Access Compliance Report

Public Rights-of-Way

(Curb Ramps)

Intersection ID: 12925	Main Street: S_CHURCH_ST	Cross Street: W_CARSON_BV	Location: SW
ADA ID: AED81B82C918	Ramp Type: ParaDiag	Initial Pass/Fail: Fail	Overall Compliance: No
		Severity Score: 12.5

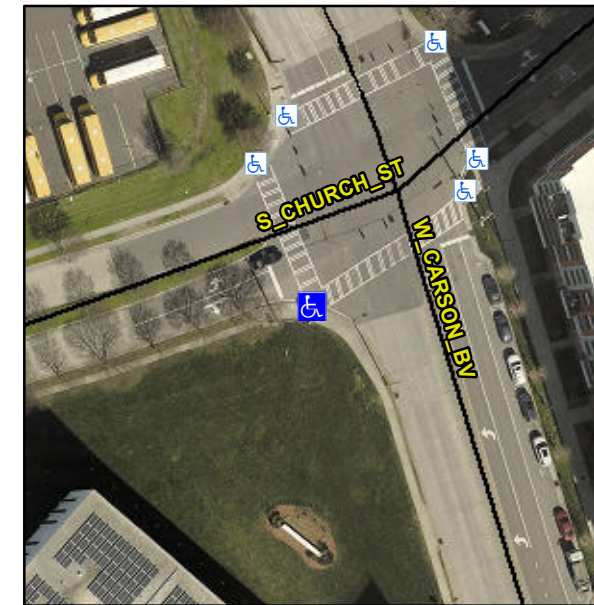
Compliance	Description	Data	Compliance	Description	Data
N/A	Ramp Length LT (in)	65.0	N/A	Ramp Length RT (in)	N/A
Yes	Ramp Width LT (in)	97.0	N/A	Ramp Width RT (in)	N/A
No	Ramp Slope LT (%)	11.1	N/A	Ramp Slope RT (%)	N/A
Yes	Ramp XSlope LT (%)	1.2	N/A	Ramp XSlope RT (%)	N/A
N/A	Landing Length (in)	N/A	N/A	DWS Provided?	N/A
N/A	Landing Width (in)	N/A	N/A	DWS Contrast?	N/A
N/A	Landing Slope (%)	N/A	N/A	DWS Length (in)	N/A
N/A	Landing X Slope (%)	N/A	N/A	DWS Full Width?	N/A
N/A	Landing Curb? (Y/N)	N/A	N/A	DWS Offset (in)	N/A
N/A	Shared Landing?	N/A			
N/A	Gutter Ponding?	N/A	N/A	Gutter Slope (%)	N/A
N/A	Gutter Lip Ht (in)	N/A	N/A	Gutter X Slope (%)	N/A
N/A	Painted X Walk1?	Yes	N/A	Painted X Walk2?	Yes
	X Walk 1 Direction	To NE		X Walk 2 Direction	To NW
N/A	X Walk 1 Width (in)	112.0	N/A	X Walk 2 Width (in)	114.0
	X Walk 1 Slope (%)	2.0		X Walk 2 Slope (%)	0.9
	X Walk 1 X Slope (%)	4.2		X Walk 2 X Slope (%)	1.2

N/A	Ramp inside XWalk1?	Yes	N/A	Ramp inside XWalk2?	Yes
	Road Slope (%)	4.8	N/A	Clear Space?	N/A
	Road X Slope (%)	0.9	N/A	Clear Space to XWalk (in)	N/A
N/A	Any Obstructions?	N/A	N/A	Storm Grate/Utility Hazard?	N/A
	Obstruction Type			Storm Grate/Utility Type	
		N/A			N/A
			Yes	Surface Condition? (G/P)	Good
			N/A	Curb Slope (%)	13.3

Possible Solutions:

Remove & Replace Curb Ramp With Two New Directional Ramps or Equivalent.

R304.3.2
